ADA Curb Ramp New Construction Inspection Form (Perpendicular)

Nw 287

24952.54

Nw may

PERPENDICULAR RAMP (PR)

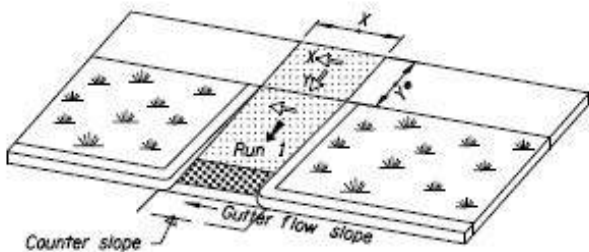
IITD RR1 fail
